FED. ROAD DIST. NO.	STATE	PROJ. NO.	FISCAL YEAR	SHEET NO.	TOTAL SHEETS
HAWAII	HAW.	139A-01-05M	2005	ADD.52	106

6/07/07	Replace with updated version, per Addendum No. 1.
---------	---

STATE OF HAWAII DEPARTMENT OF TRANSPORTATION HIGHWAYS DIVISION
<u>CURB RAMP AND SIDEWALK NOTES</u>
<u>OLD KEAAU-PAHOA ROAD RESURFACING</u>
<u>KEAAU TO KEAAU HIGH SCHOOL</u>
<u>PROJECT NO. 139A-01-05M</u>
Date: Nov., 2004

Scale: 1/2" = 1'-0"

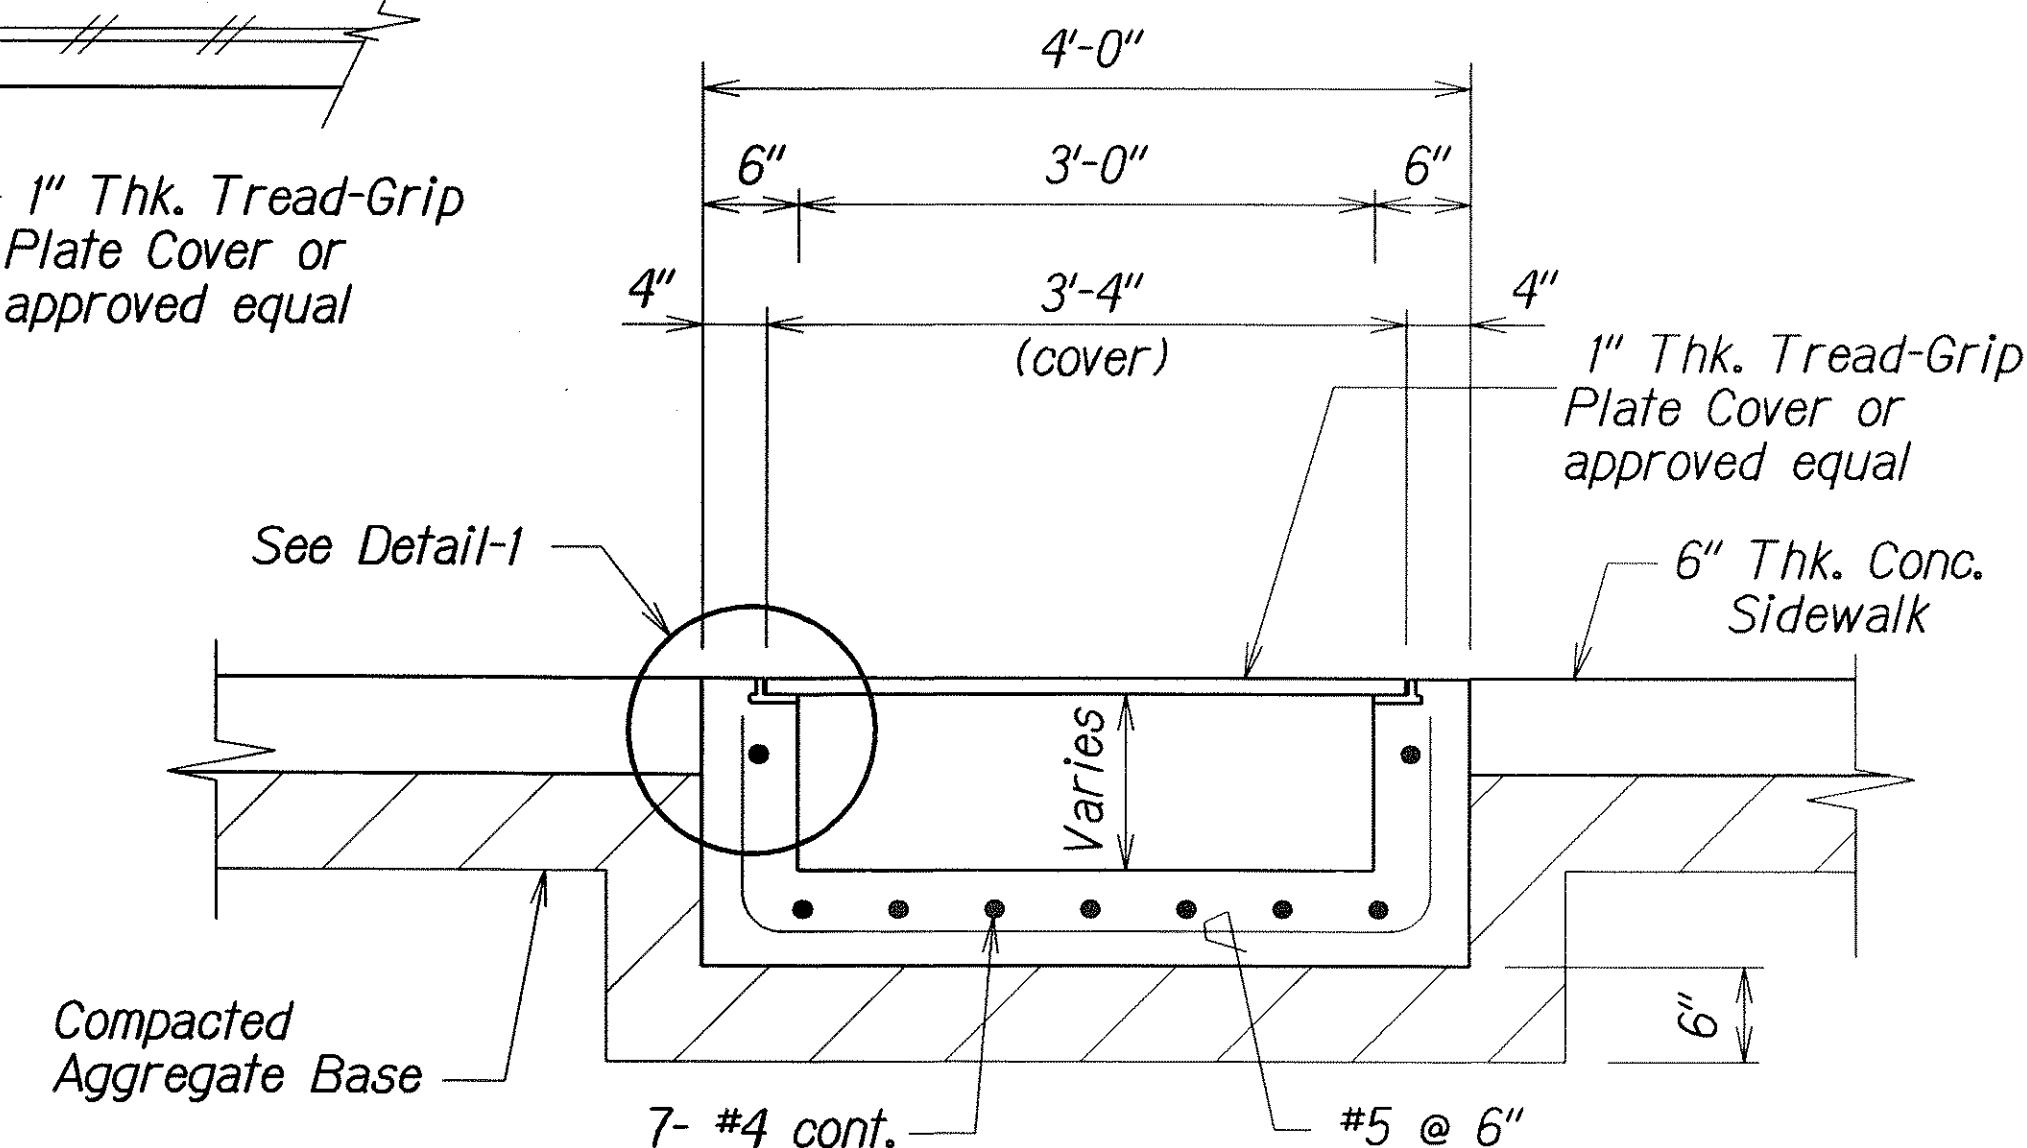
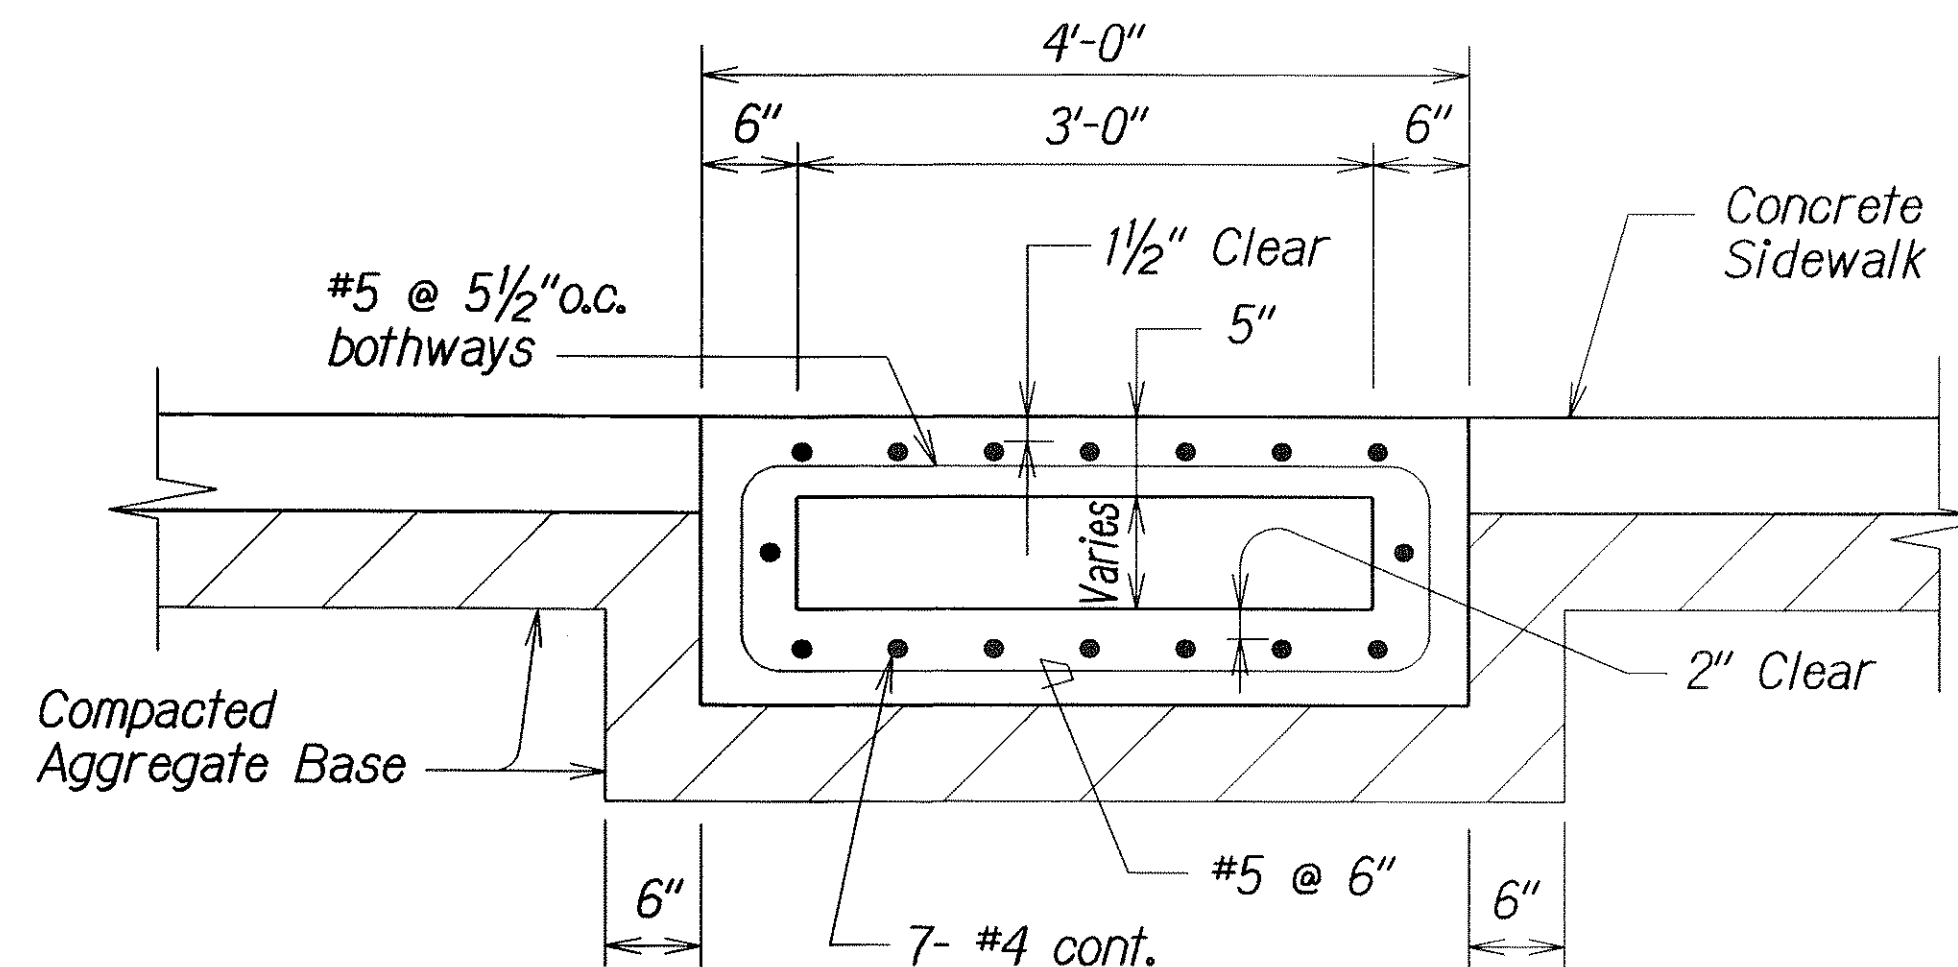
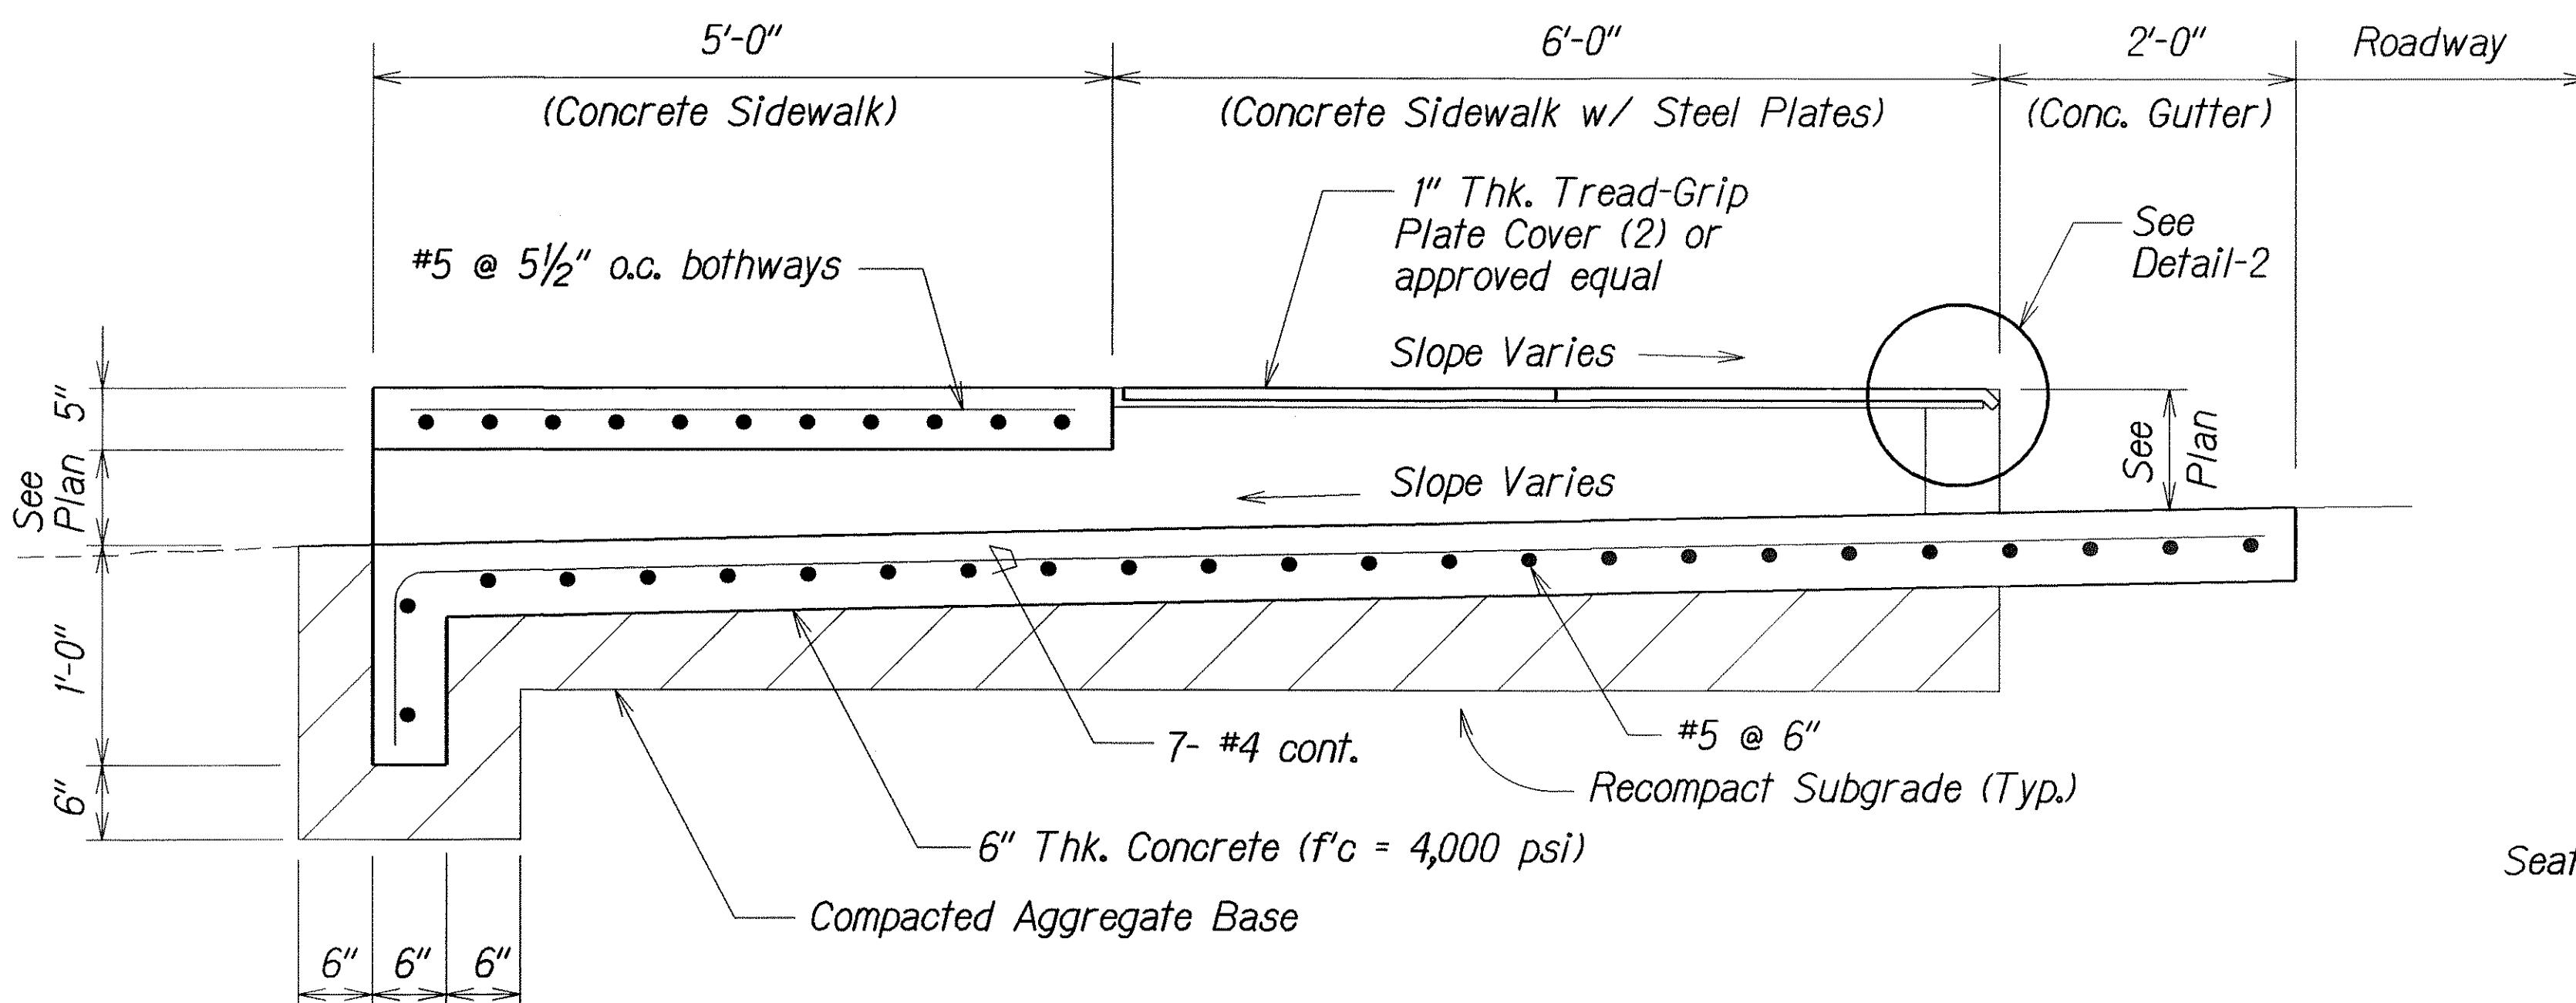
6/07/07 Revise culvert details and notes, per Addendum No. 1.
